JOINT REGIONAL PLANNING PANEL
(Sydney West Region)

JRPP Number	2015SYW075
DA Number	DA/371/2015 (Lodged 7 April 2015)
Local Government Area	Hornsby
Proposed Development	Demolition of existing structures and concept proposal for a 25 storey mixed use development comprising 220 residential units, entertainment facility, retail and commercial floor space and 8 levels of basement car parking.
Street Address	Lots 18, 19, 20, 21 & 22, DP 13812, Lot 1, DP 114653, Lot 1, DP 1053591, Lot 1, DP 171959, Lot 1, DP 171958, Lot 1, DP 172708, Lot A, DP 325525, No.s 240 – 260 Peats Ferry Road, Hornsby.
Applicant/Owner	Ezzy Architects / P & L Properties Pty Ltd, Mr T Poulos and Estate Late Mr G Lorandos, Easty Pty Ltd, Gwynvill Properties Pty Ltd
Number of Submissions	24 submissions, including a petition with 465 signatures
Regional Development Criteria (Schedule 4A of the Act)	The DA is referred to the JRPP pursuant to Schedule 4A of the Environmental Planning and Assessment Act 1979, as amended. The Panel is authorised to exercise the consent authority functions of Council as the development proposed has a combined capital investment value of more than \$20 million Capital Investment value of th

Extract of Figure 4.5(f) – HDCP

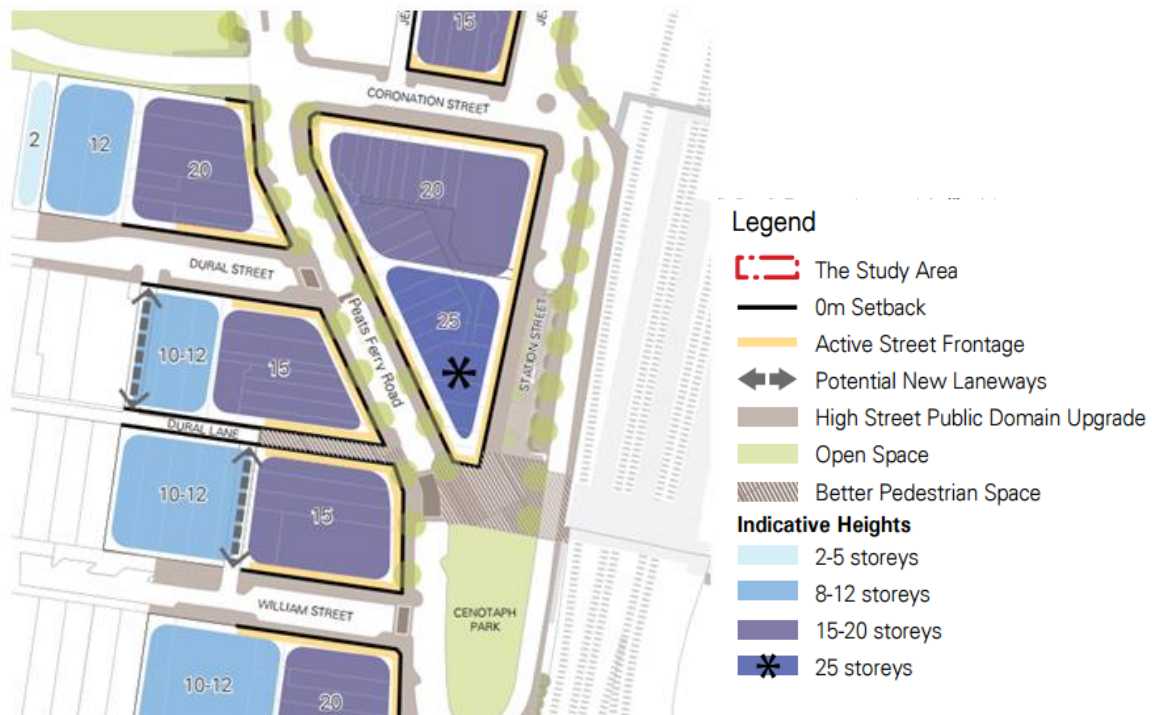
The prescriptive measures are designed to achieve compliance with the desired future character statement. To the extent that the concept plans allow assessment to be undertaken, the proposal fails to meet the key elements sought by Council in the redevelopment and revitalisation of the West Side Precinct.

Approval of the development application would have the following results inconsistent with the structure plan:

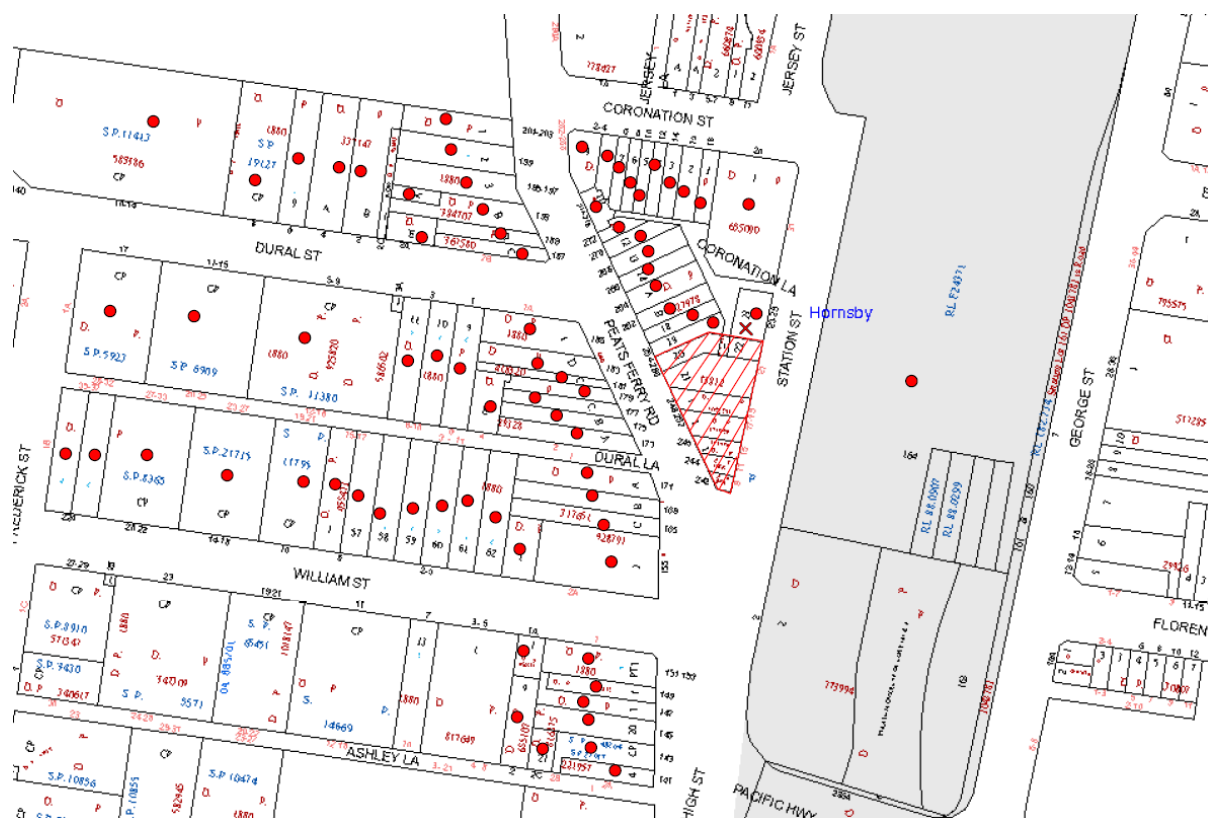
The proposed development excludes land on the same street block that has a 77.5m height limit, and effectively prevents that land from achieving anything approaching an equivalent yield.

The scale of the proposed development is inconsistent with the capability of the site and provides insufficient detail to warrant variation of the adopted planning controls.
